From: Gerry Houlder, Seagate Technology <gerry.houlder@seagate.com>
Subj: SAS-2+: Add low power transceiver options
Date: Aug. 11, 2008

SAS-2+ Changes (based on SAS-2 rev.14):

Figure new1 – SAS transition to power management

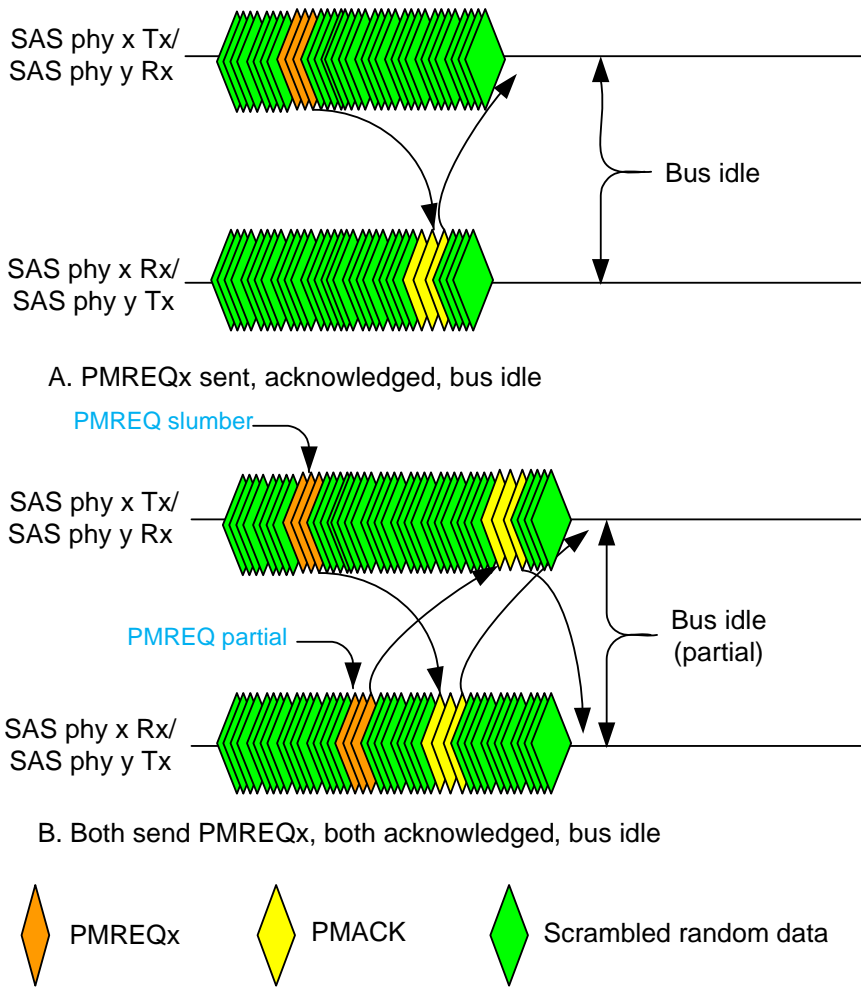
Figure new1-A shows a transition from both ends sending scrambled data to bus idle. The sequence proceeds as follows:

- 1) phy x sends PMREQ (x) primitive to phy y;
- 2) phy y sends PMACK primitive to phy x; and
- 3) both phys transition to the requested bus idle condition.

Figure new1-B shows a transition when both phy x and phy y send a PMREQ (x) primitive at the same time:

- 1) phy x sends PMREQ (x) primitive to phy y;
- 2) phy y sends PMREQ (x) primitive to phy x before it receives the primitive sent by phy x;
- 3) phy y sends PMACK to acknowledge receipt of phy x PMREQ (x) primitive but doesn't transition to bus idle yet;
- 4) phy x sends PMACK to acknowledge receipt of phy y PMREQ (x) primitive; and
- 5) both phys transition to the agreed upon bus idle condition.

Figure new2 – SAS COMWAKE wakeup sequence

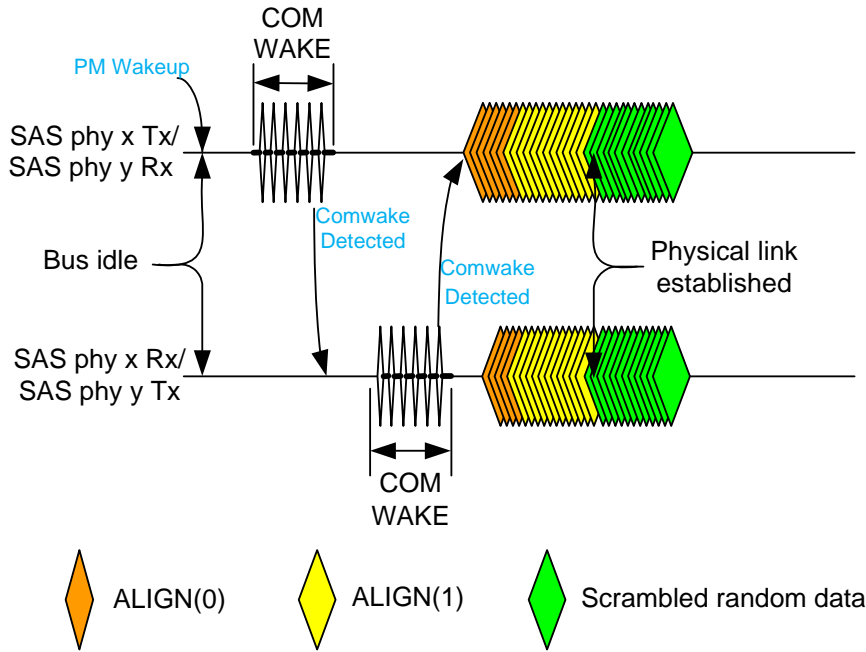
- 1) port x decides to wake up the link and initiates power management action to transition phy x to active state;
- 2) phy x transmits COMWAKE;
- 3) phy y detects COMWAKE, initiates power management action to transition phy y to active state, and transmits COMWAKE back to phy x;
- 4) both phys transmit ALIGN(0) primitives at previously negotiated settings;
- 5) when both receivers synchronize on ALIGN(0)s, the transmitters change to sending ALIGN(1)s; and
- 6) when both receivers synchronize on ALIGN(1)s, the transmitters change to idle dwords.

[Note: should different ALIGN primitives be chosen instead of ALIGN(0) and ALIGN(1)?]

Figure new3 – WAKEUP hot-plug examples

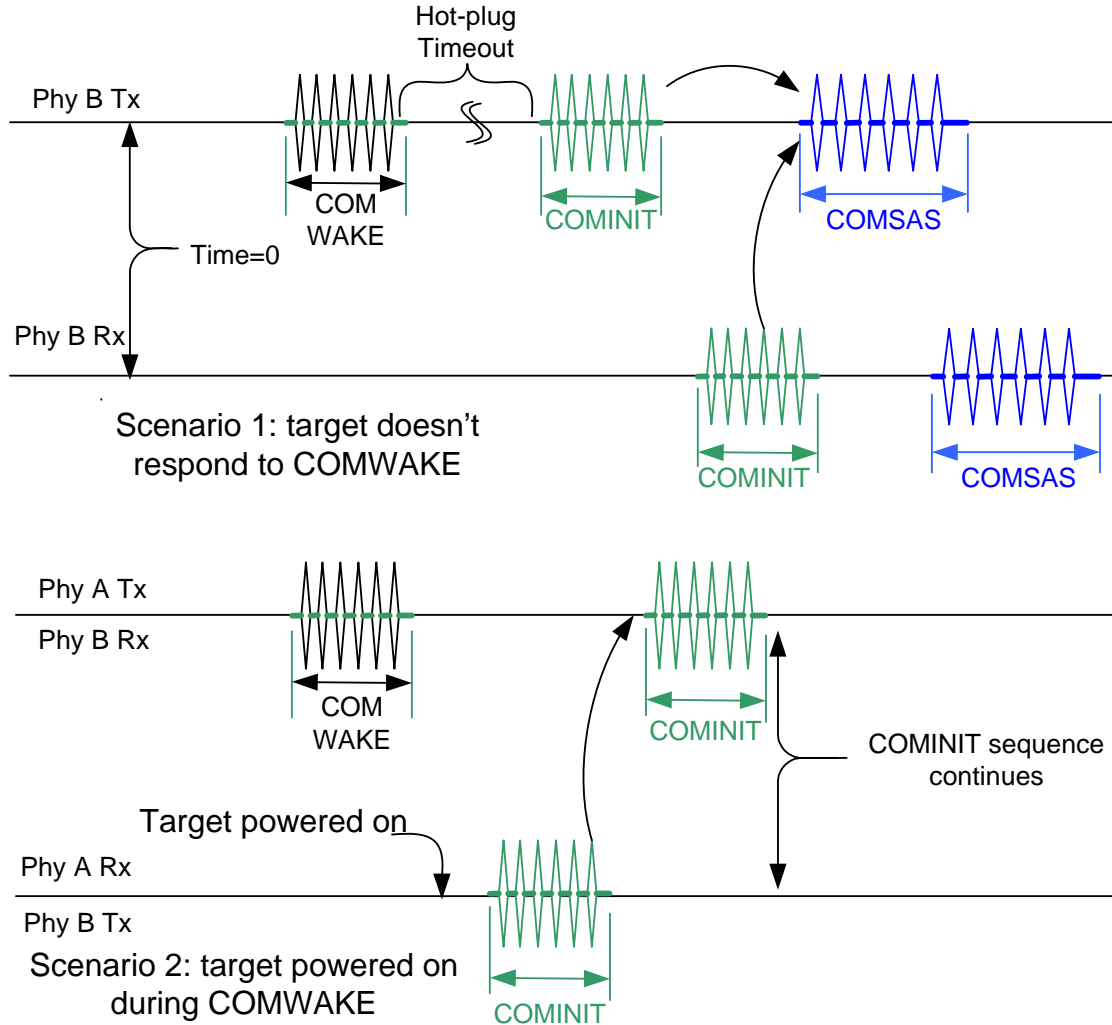
- 1) a SCSI initiator starting a power management wakeup sequence;
- 2) the SCSI target doesn't respond within timeout limit; and
- 3) the SCSI initiator recovers by changing to COMINIT sequence.

- 1) a SCSI initiator starting a power management sequence;
- 2) the SCSI target is powered on and begins COMINIT sequence within the timeout limit; and
- 3) the SCSI initiator proceeds by continuing the COMINIT sequence.

[Note: For scenario 1, is hot-plug timeout (500 ms) correct (this was suggested at last telecon), or should we define a new timeout that could be as small as 10 ms? Expander might be expecting

partial recovery (within 10 us) and already sent AIP (WAITING ON DEVICE) to initiator. Even if it was expecting slumber recovery (within 10 ms) and had sent OPEN REJECT (RETRY) there might be issues with a wait as long as 500 ms before the expander marks the port as “no device attached”.]
